Date: March 15, 2018  
To: Cumberland Planning Board  
From: Carla Nixon, Town Planner  
Subject: OceanView at Cumberland - Major Subdivision Preliminary Plan Review

Date March 15, 2018  
To Town of Cumberland Planning Board  
From Carla Nixon, Town Planner  
Subject **Major (Preliminary) Subdivision Review: Oceanview @ Cumberland. 277 Tuttle Road**

As requested, Sevee & Maher Engineers, Inc. (SME) has completed a review of the comment responses submitted for the preliminary application for a Major Subdivision and Site Plan for the proposed OceanView at Cumberland senior living community located off Tuttle Road. This submission is identified by the applicant as Revised Preliminary Subdivision Plan Submittal – Addenda-1A. The application materials received by SME were prepared by LICHT Environmental Design, LLC (LICHT), and consist of the following:

## TYPICAL PRECAST CONCRETE CATCH BASIN

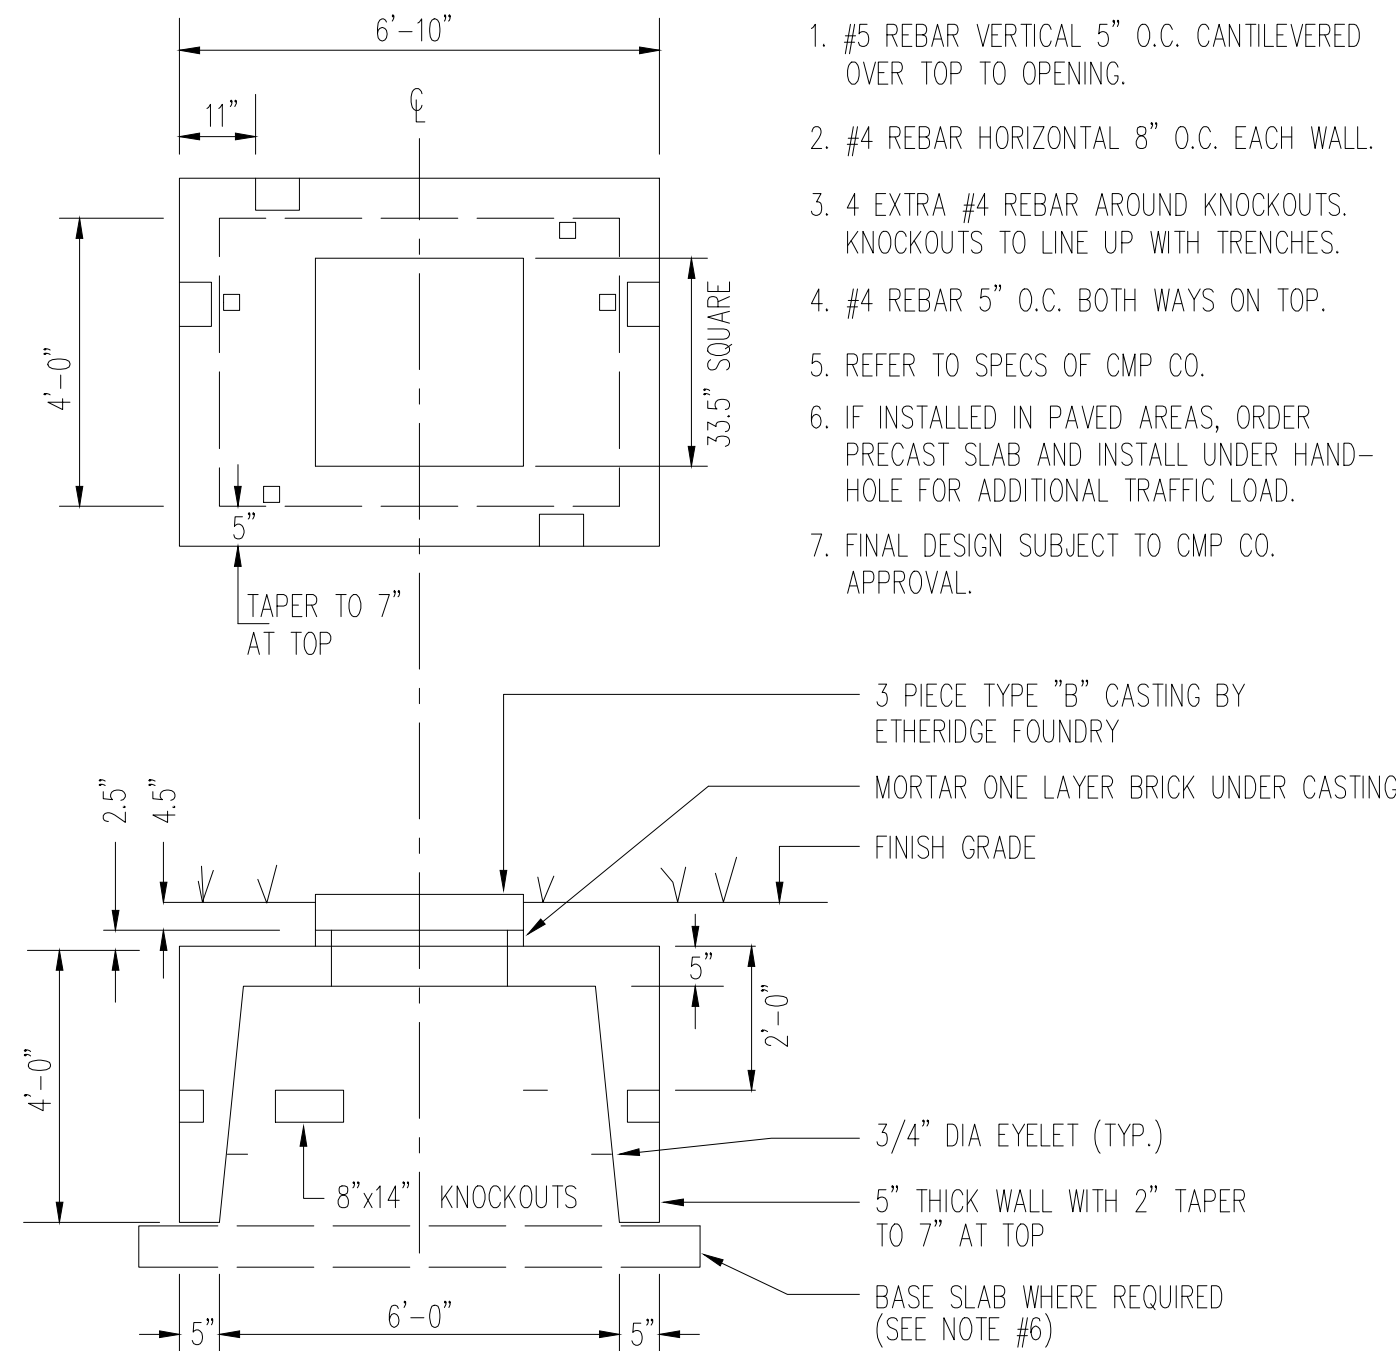
34. Civil details C15 – The Town of Cumberland does not usually include ladder rungs in catch basin structures. SME recommends the applicant amend the plans to reflect Town construction standards.

34. Civil details C15 – The Town of Cumberland does not usually include ladder rungs in catch basin structures. SME recommends the applicant amend the plans to reflect Town construction standards. *The catch basin detail has been revised.*

## PERIMETER OR FOUNDATION DRAIN DETAIL

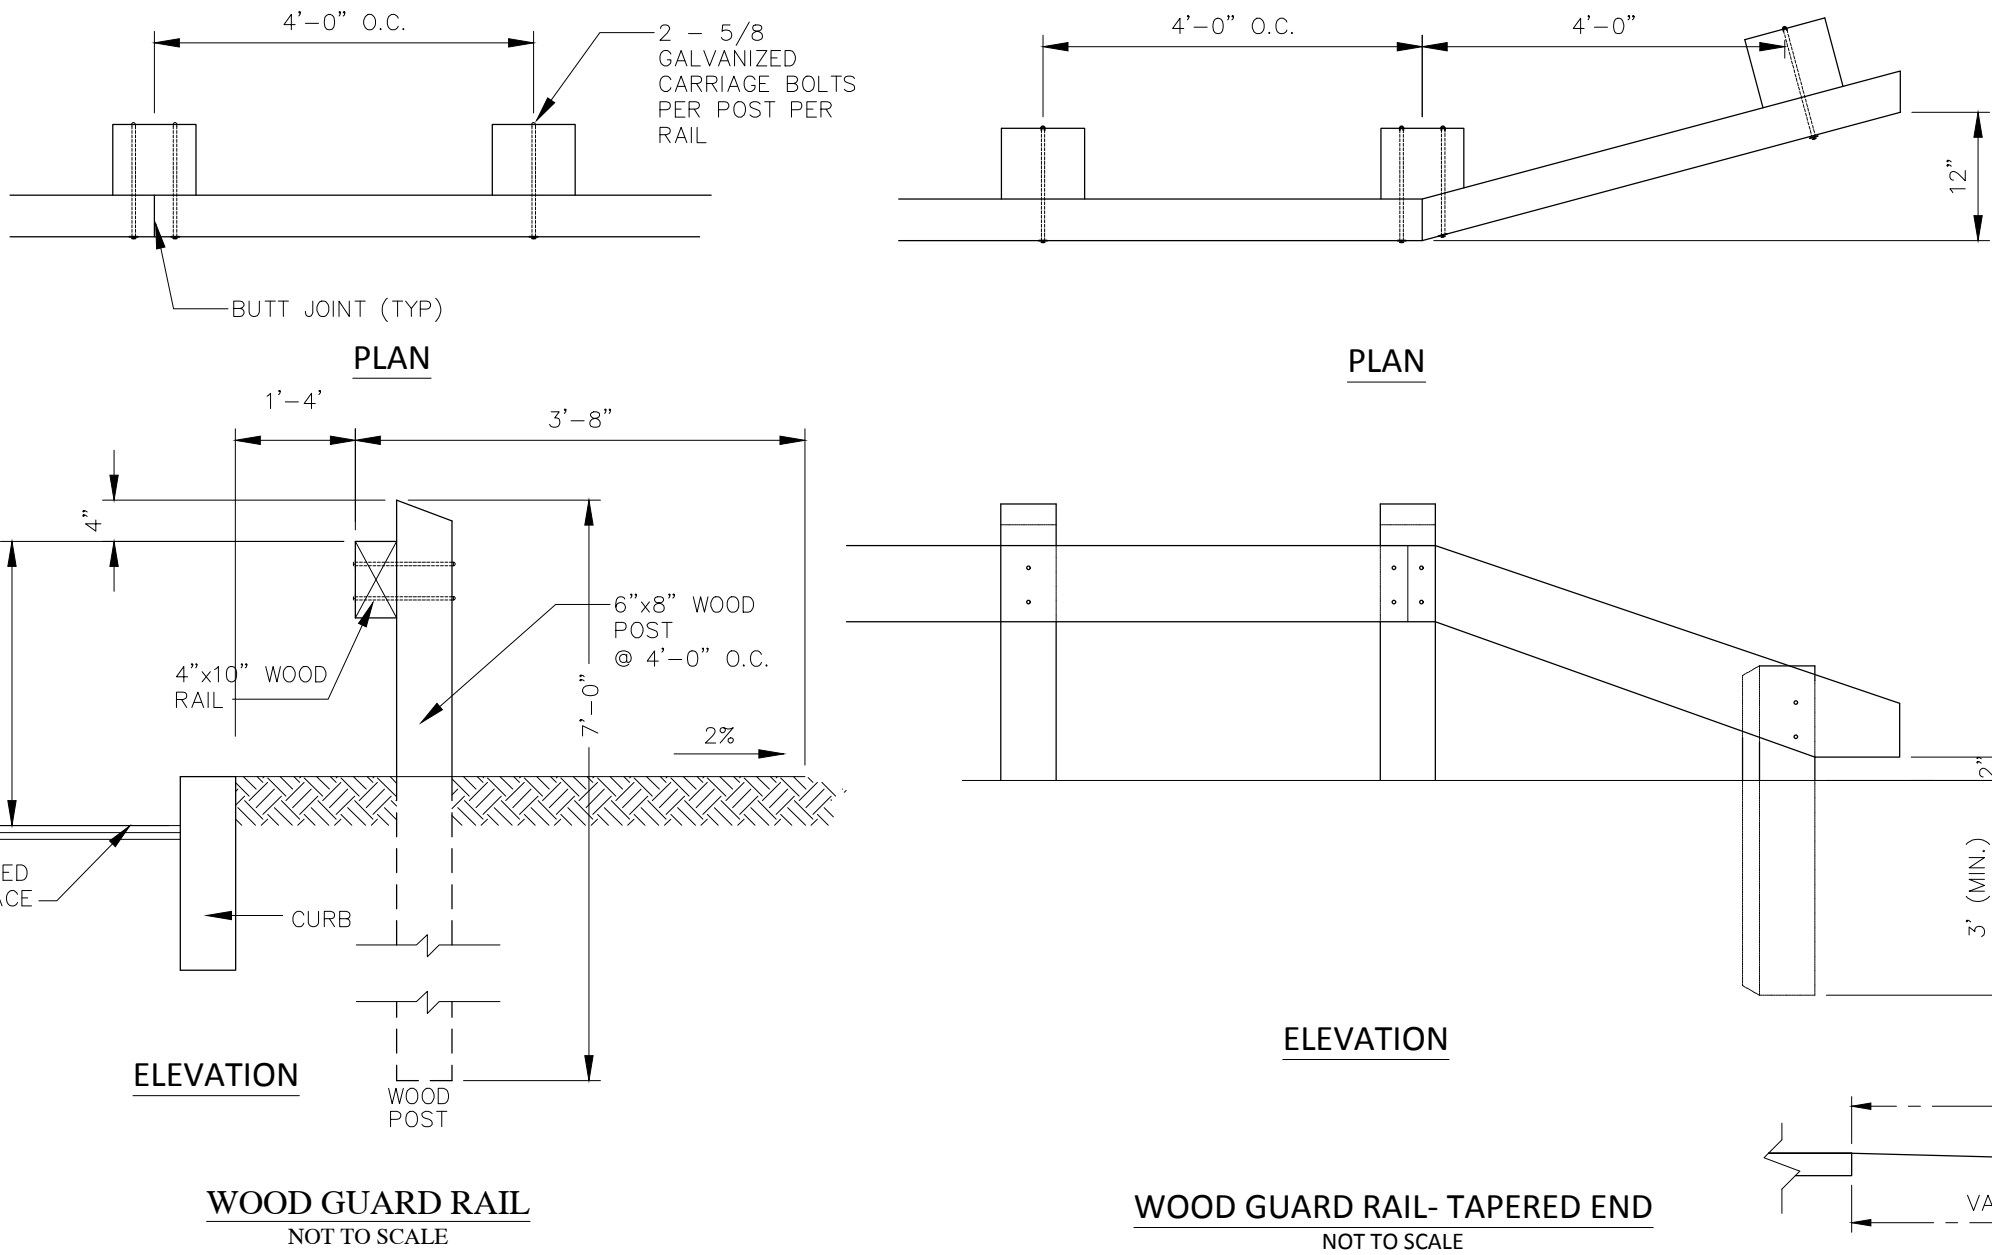
- ~~21. Where will foundation drains empty? Detail on C19. Foundation drains will connect to storm drains with backflows where grades allow and will discharge by gravity in other cases to low areas around units.~~
